LAND USE APPLICATION SUMMARY

Property Location: 1600 East 19th Street
Project Name: Anishinabe Bii Gii Wiin
Prepared By: Hilary Dvorak, Principal Planner, (612) 673-2639
Applicant: American Indian Community Development Corporation (AICDC)
Project Contact: Scott Nelson with DJR Architecture, Inc.
Request: To allow an assisted living facility with 32 beds.
Required Applications:

The purpose of the Preliminary Development Review (PDR) is to provide Customers with comments about their proposed development. City personnel, who specialize in various disciplines, review site plans to identify issues and provide feedback to the Customers to assist them in developing their final site plans.

C2.0

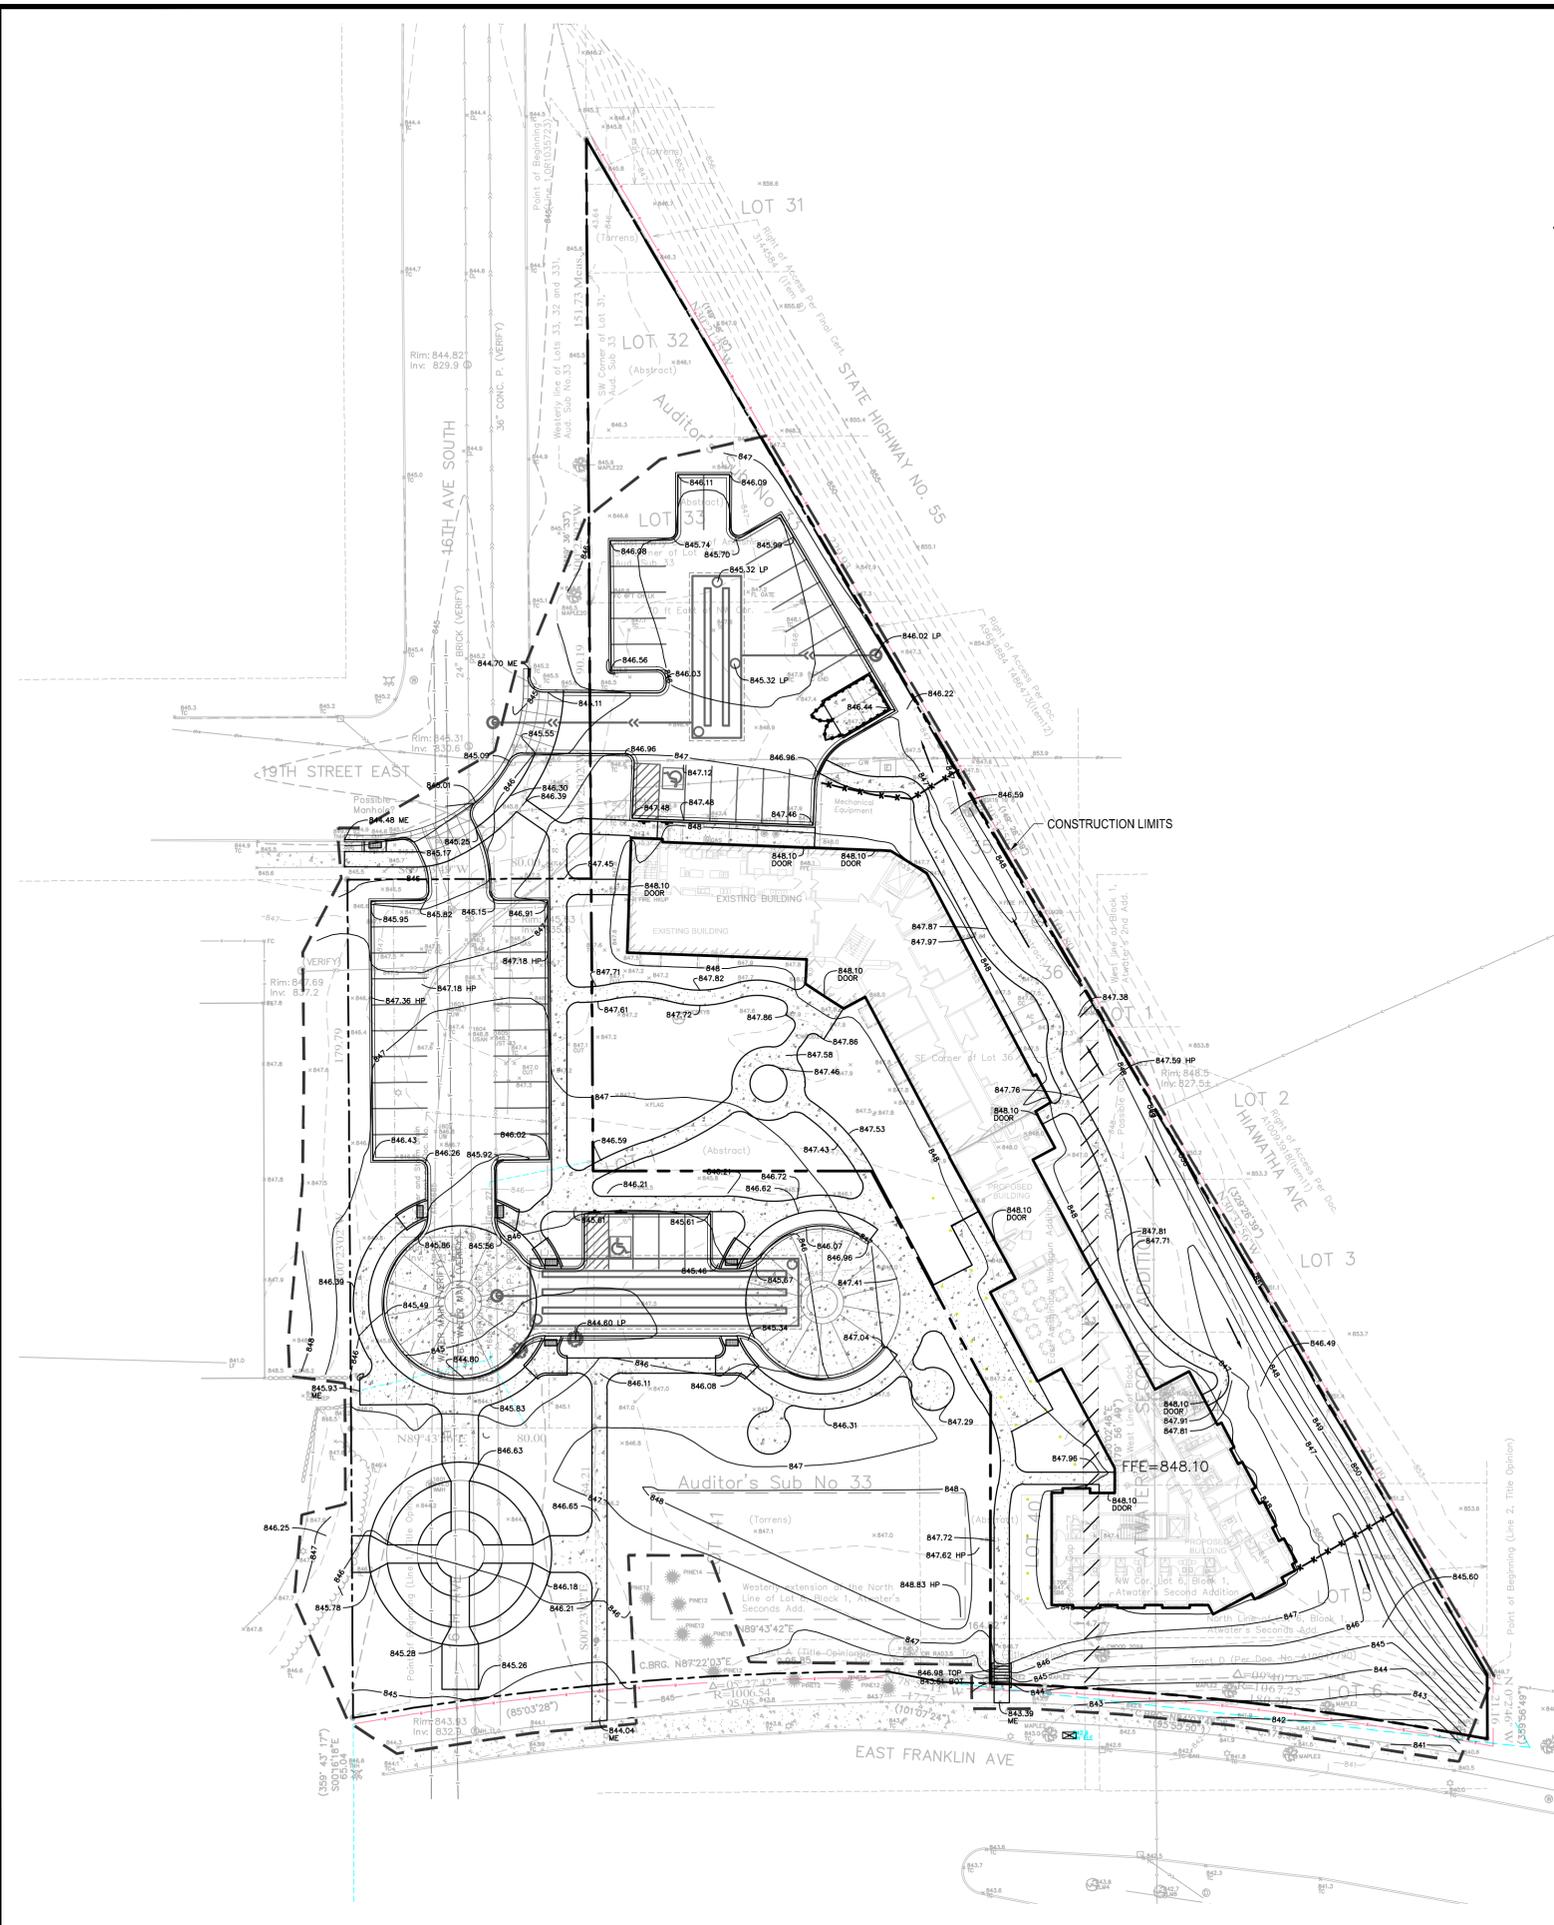
- All driveway aprons shall be designed and constructed to City standards. All driveway aprons shall be shown graphically correct on all related plan sheets. On Sheet C2.0 include a reference the appropriate details on Sheet C5.0 of the plans. The proposed curb radius is not shown correctly; the plans shall indicate the correct radius for the proposed curb and driveway (65'radius per City records).
